THE HONG KONG HOUSING AUTHORITY

Memorandum for the Building Committee

New Cruciform Block Revised Kitchen & Bathroom Layouts and Design Amendments

REVISED KITCHEN & BATHROOM LAYOUTS AND DESIGN AMENDMENTS

● **FLAT A** *2 bedroom flat*

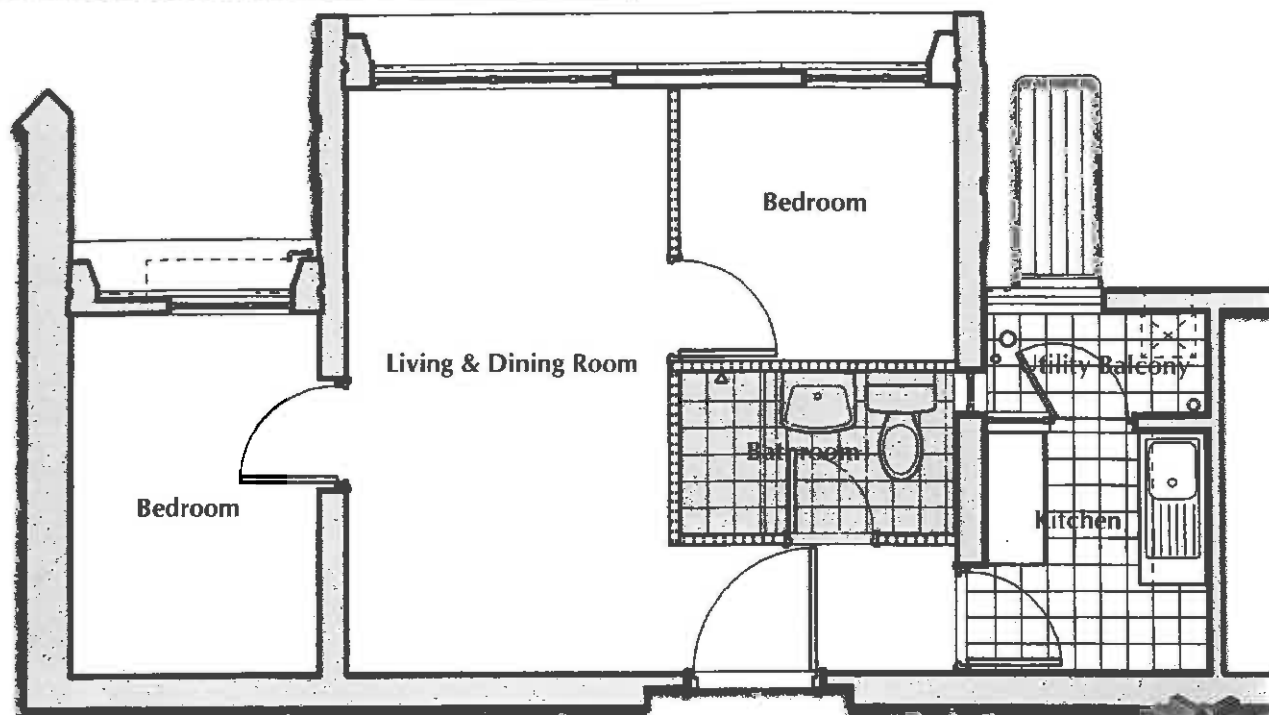
Revised Flat Layout

Existing Flat Layout

Kitchen Layout

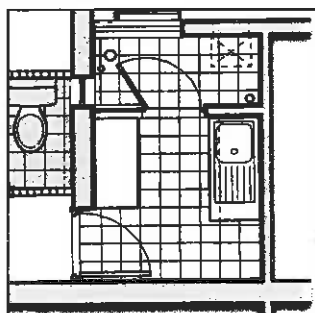
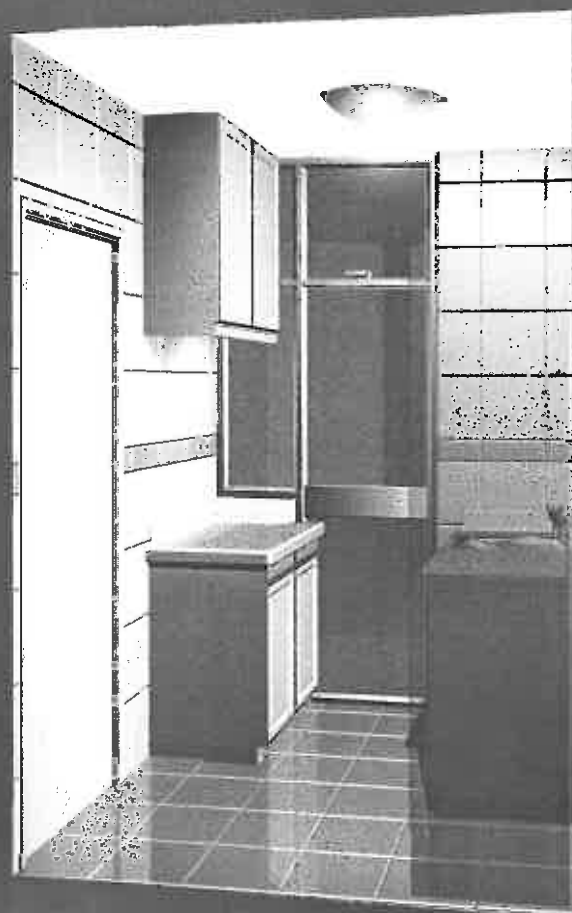
- Revised kitchen layout and cabinet design to accommodate the future electrical household appliances more neatly.
- Additional floor and wall cabinets for more storage space, and additional worktop at the utility balcony.
- To conceal all drainage and services pipes inside the cabinets as far as practicable.
- Postforming laminate worktop with inlaid stainless steel sink.

- The floor and wall tiles are revised from 200mm x 200mm homogeneous / ceramic tiles to 300mm x 300mm homogeneous / ceramic tiles.

- All communal drainage pipes originally installed inside duct in the flat and have taken up space are relocated to the external wall.

Bathroom Layout

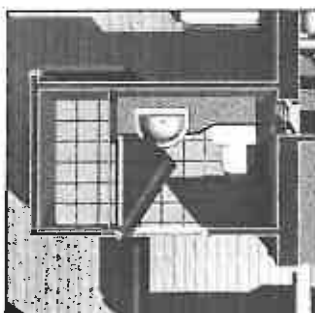
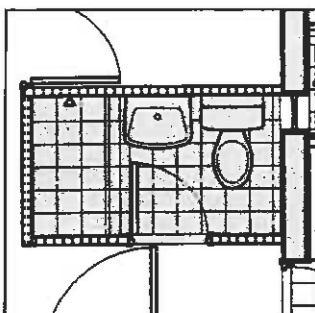
- Provision of shower area and curtain rod.
- Provision of cabinet and postforming laminate worktop in bathroom for more storage space and to conceal all drainage and services pipes inside the cabinet as far as practicable.
- Deletion of mirror cabinet and replaced by a large single piece mirror.

- The floor and wall tiles are revised from 200mm x 200mm homogeneous / ceramic tiles to 300mm x 300mm homogeneous / ceramic tiles.

- All communal drainage pipes originally installed inside duct in the flat and have taken up space are relocated to the external wall.

● FLAT B *3 bedroom flat*

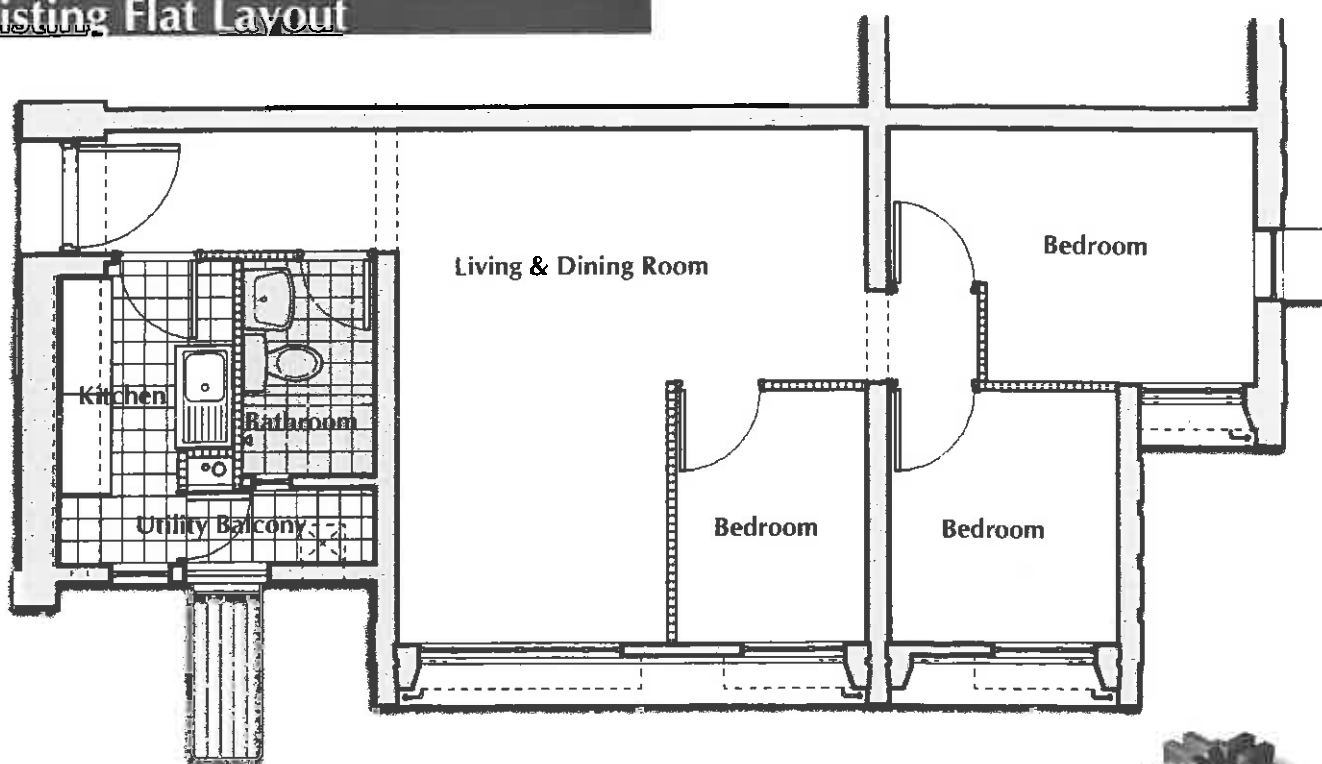
Revised Flat Layout

Existing Flat Layout

Kitchen Layout

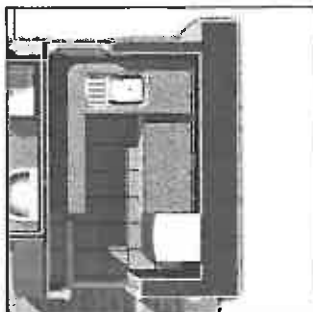
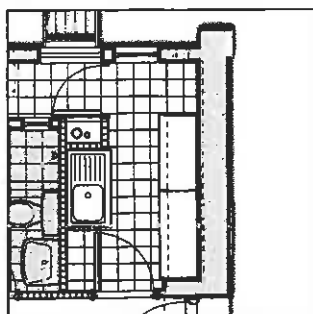
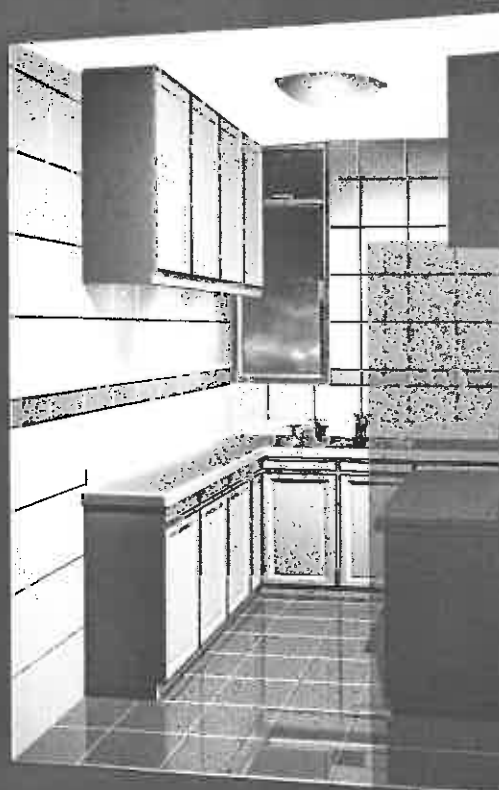
- Revised kitchen layout and cabinet design to accommodate the future electrical household appliances more neatly.
- Additional floor and wall cabinets for more storage space.
- To conceal all drainage and services pipes inside the cabinets as far as practicable.
- Postforming laminate worktop with inlaid stainless steel sink.

- The utility balcony is deleted to allow more space for the kitchen and a more efficient layout. This is also to eliminate the illegal window enclosures commonly provided by the owners.

- The floor and wall tiles are revised from 200mm x 200mm homogeneous / ceramic tiles to 300mm x 300mm homogeneous / ceramic tiles.

- All communal drainage pipes originally installed inside duct in the flat and have taken up space are relocated to the external wall.

Bathroom Layout

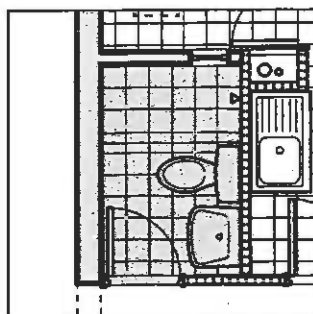
- Provision of shower area and curtain rod.
- Provision of cabinet and postforming laminate worktop in bathroom for more storage space and to conceal all drainage and services pipes inside the cabinet as far as practicable.
- Deletion of mirror cabinet and replaced by a large single piece mirror.
- Additional space for storage cabinet next to the bathroom.

- The floor and wall tiles are revised from 200mm x 200mm homogeneous / ceramic tiles to 300mm x 300mm homogeneous / ceramic tiles.

- All communal drainage pipes originally installed inside duct in the flat and have taken up space are relocated to the external wall.

● FLAT C *3 bedroom flat*

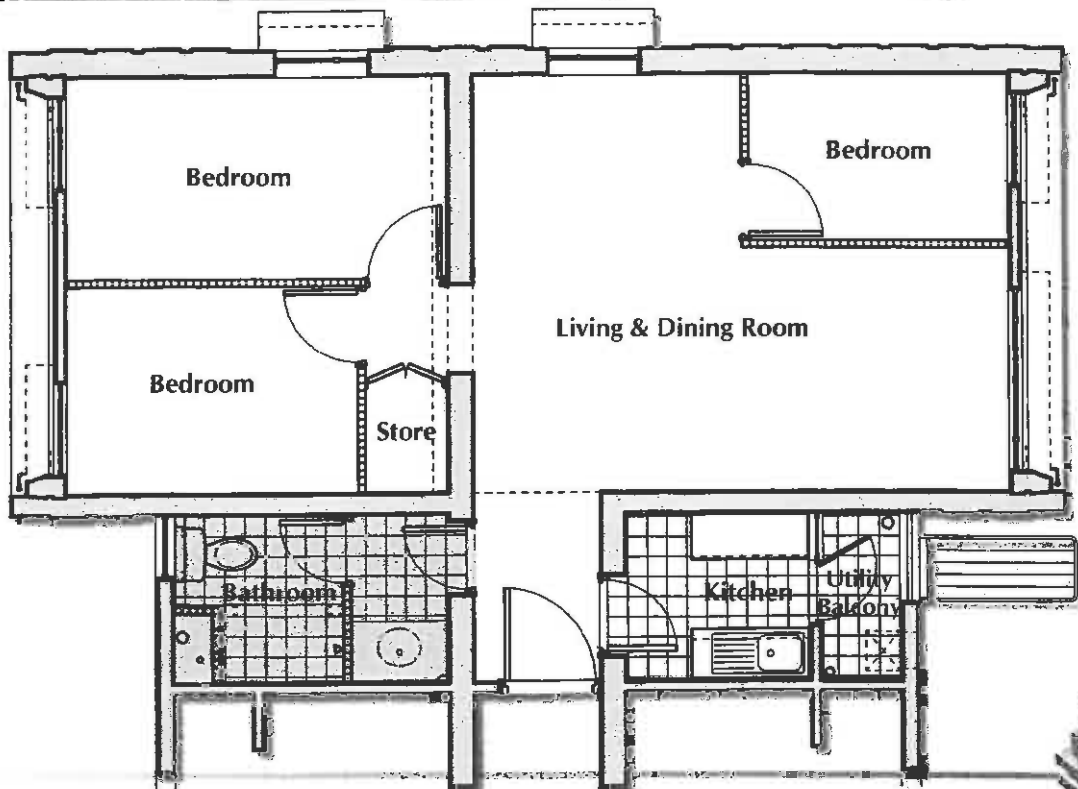
Revised Flat Layout

Existing Flat Layout

Kitchen Layout

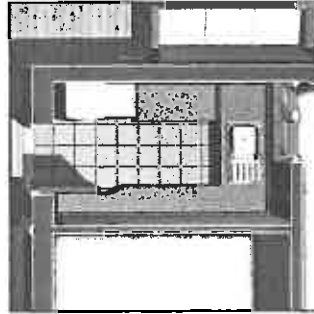
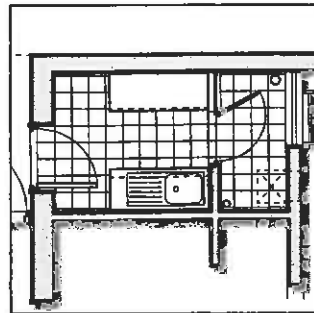
- Revised kitchen layout and cabinet design to accommodate the future electrical household appliances more neatly.
- Additional floor and wall cabinets for more storage space.
- To conceal all drainage and services pipes inside the cabinets as far as practicable.
- Postforming laminate worktop with inlaid stainless steel sink.

- The utility balcony is deleted to allow more space for the kitchen and a more efficient layout. This is also to eliminate the illegal window enclosures commonly provided by the owners.

- The floor and wall tiles are revised from 200mm x 200mm homogeneous / ceramic tiles to 300mm x 300mm homogeneous / ceramic tiles.

- All communal drainage pipes originally installed inside duct in the flat and have taken up space are relocated to the external wall.

Bathroom Layout

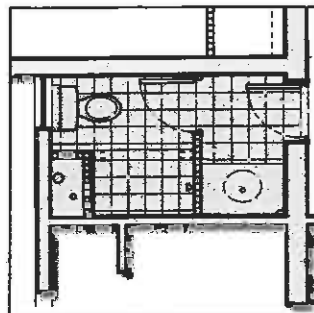
- Provision of shower area and curtain rod.
- Provision of cabinet and postforming laminate worktop in bathroom for more storage space and to conceal all drainage and services pipes inside the cabinet as far as practicable.
- Deletion of mirror cabinet and replaced by a large single piece mirror.
- Additional space for storage cabinet next to the bathroom.

- The floor and wall tiles are revised from 200mm x 200mm homogeneous / ceramic tiles to 300mm x 300mm homogeneous / ceramic tiles.

- All communal drainage pipes originally installed inside duct in the flat and have taken up space are relocated to the external wall.
